Closure Sampling and Analysis Plan for
Medical Training Facility

Westover Air Reserve Base
Massachusetts

**RESPONSE TO COMMENTS ON DRAFT AND DRAFT FINAL
CLOSURE SAMPLING AND ANALYSIS PLAN**

FIGURE 2.2

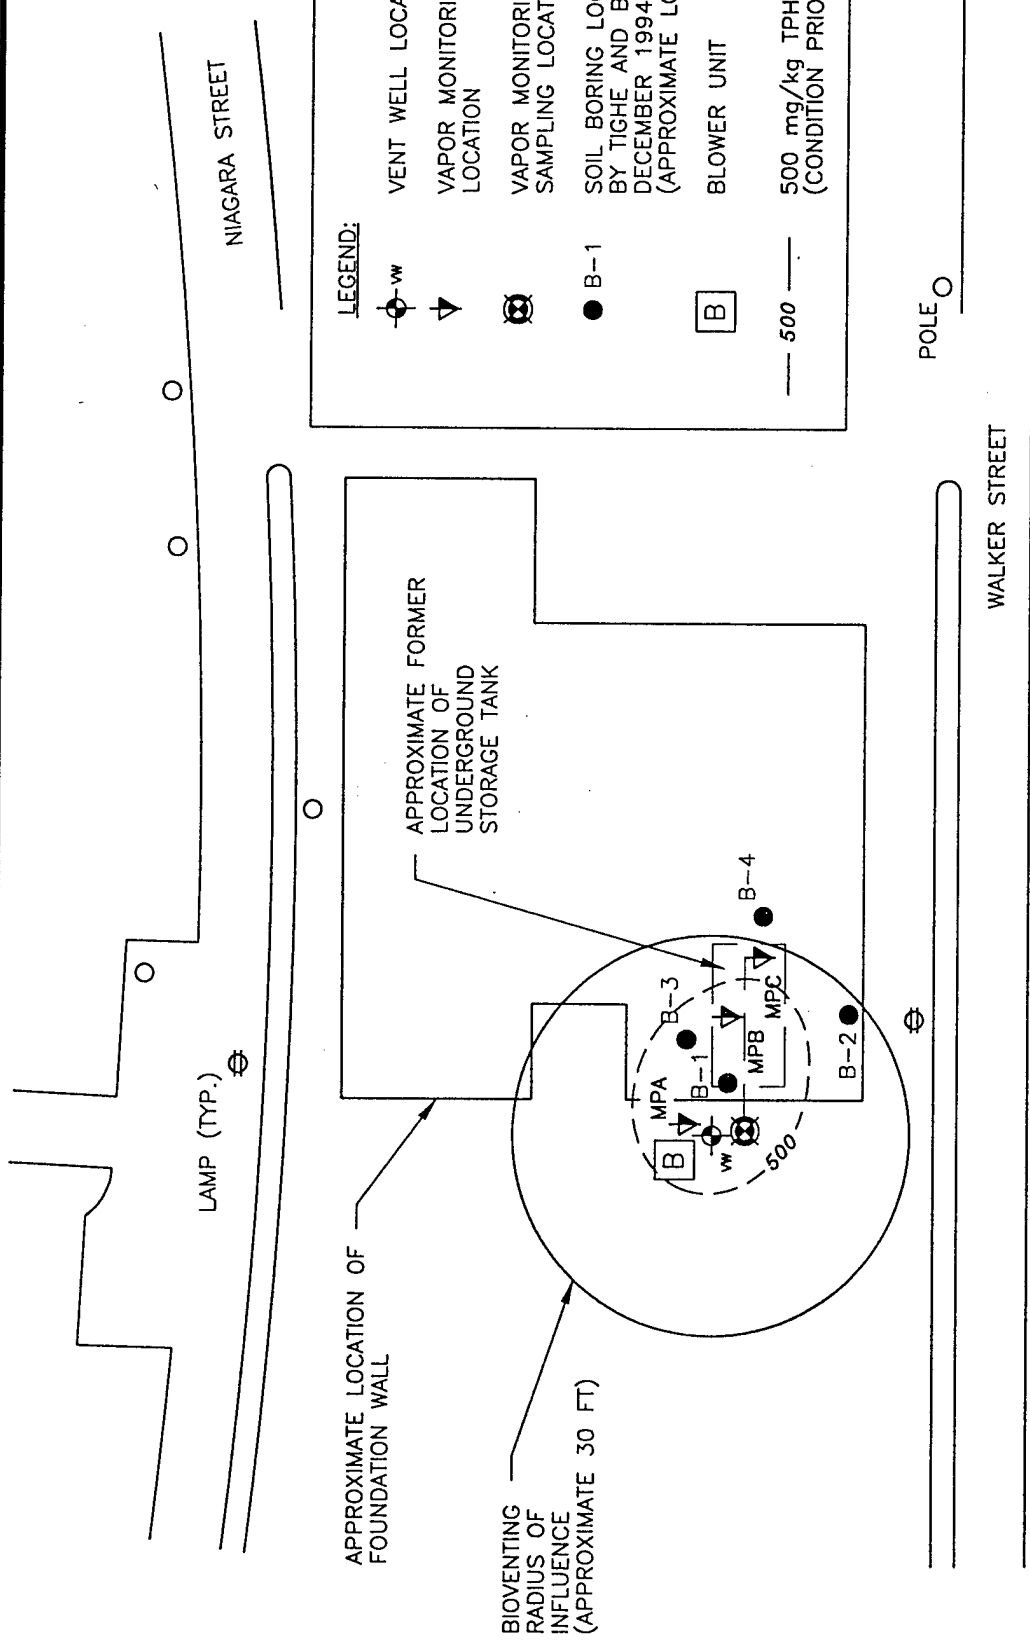
6. *As stated in the report, “the angled boreholes will be drilled at approximately a 45 degree angle, beginning 15 feet away from the building foundation.” These boreholes will be completed to 30 feet below the ground surface, and 15 feet within the building foundation.” On Figure 4-1 (soil sampling location) it appears that this will give you a sample at 15 feet under the foundation or in the middle of where the UST used to be located. How will the east (far) side of the*

The east end of the former UST area was sampled during an investigation by Tighe and Bond, Inc. in December 1994, location B-4 on Figure 2-2. This soil sample was collected from the 40 to 42 foot depth interval, was analyzed, and detected BTEX compounds below the method detection limit and TPH concentrations of less than 55 mg/kg. In addition, to further document the extent of contamination for the RAO, Parsons ES installed a soil vapor monitoring point (MPC) on the east end of the former UST location in April 1995. This location has shown low concentrations of field analyzed total volatile hydrocarbons (TVH) (less than 75 ppm). Therefore, Parsons ES excluded the collection and analysis of soil from this area because soil and soil gas samples have been collected from this area previously and the results showed low levels of contamination.

FIGURE 2.3

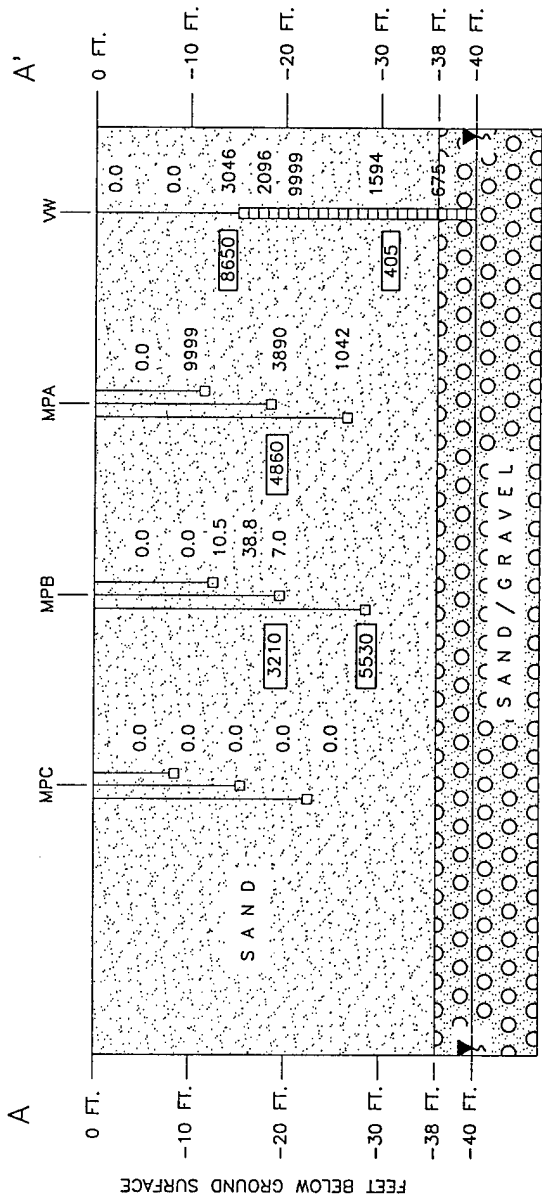
1. *Figure 2.3. All the following refer to the field and lab sample:*
 - a. *Indicate in the legend text that the lab data are gas samples*
 - b. *Are the lab data ppmv or ppm?*
 - c. *Please be consistent in upper/lower case. Field data is ppmv and lab data is PPM.*
 - a. The following change has been made to the legend on Figure 2.3; "soil gas field screening results" has been added to replace "field screening results" in the legend on Figure 2.3.
 - b. A note was added in the legend on Figure 2.3 that laboratory results are in milligram per kilogram.
 - c. All upper case PPMs were changed to lower case.
2. *Page 4-1, Section 4.1, First line in text. Replace "horizontal" with "angled"*

Done.
3. *Please verify with the Army CoE folks about the proposed procedures to refill the angled borings. I just want to make sure that there is no question about altering the foundation's integrity by improperly refilling the boreholes. They may call for filling with tremie tubes and cement (as an example) or they may say that the holes are so small that there won't be any structural impacts (hopefully). Please get their input in writing.*
